ENCLOSURE 3

PROPOSED TECHNICAL SPECIFICATIONS

Marked-up Technical Specification/Technical Specification Bases Pages:

TECHNICAL SPECIFICATION/TECHNICAL SPECIFICATION BASES

Figure 2.1.1-1 (page 1 of 1)
Reactor Core Safety Limits

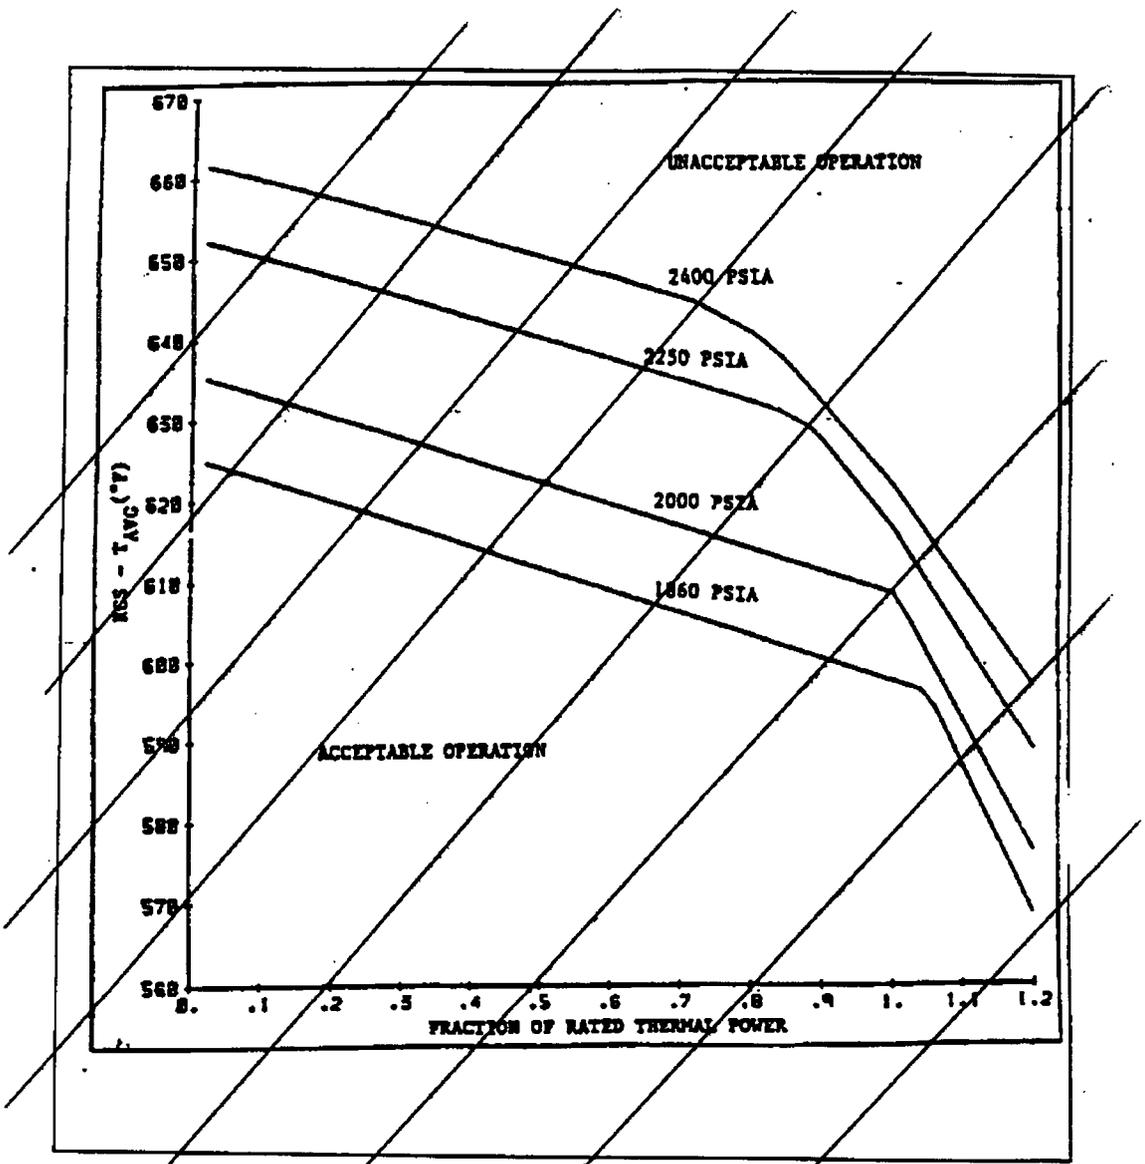
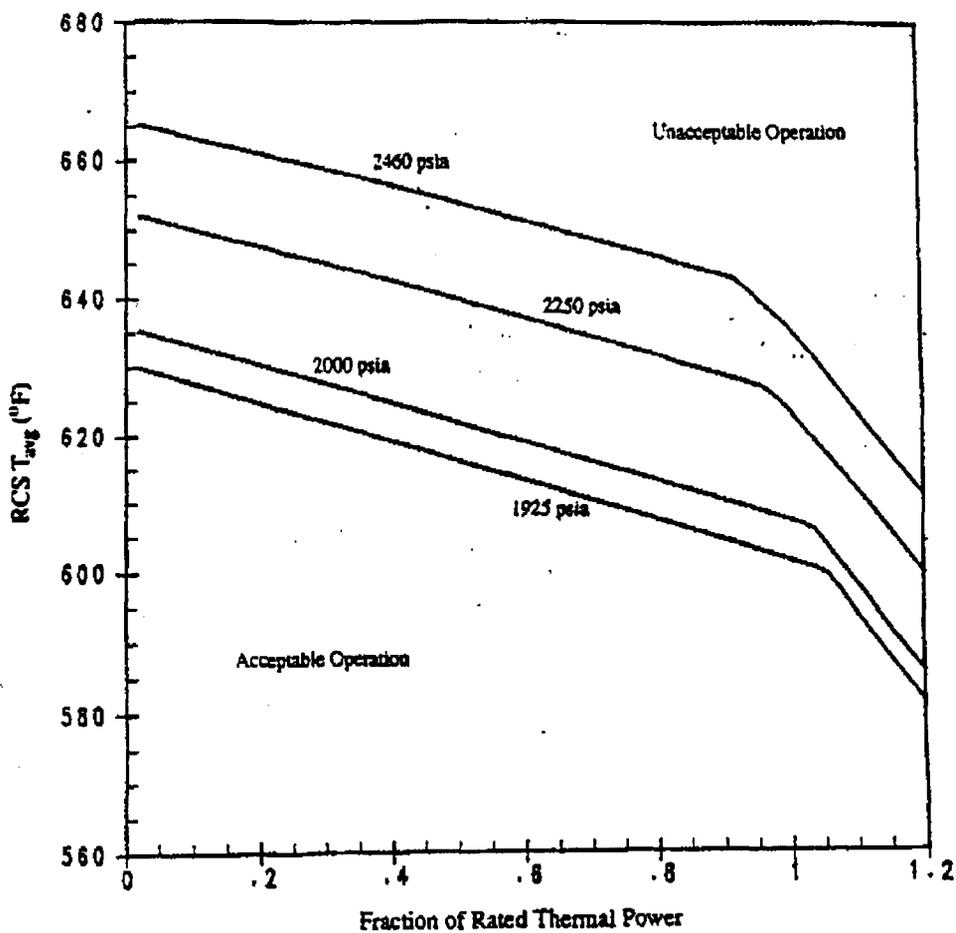
Replace with Insert 1

Insert 1 for page 2.0-2
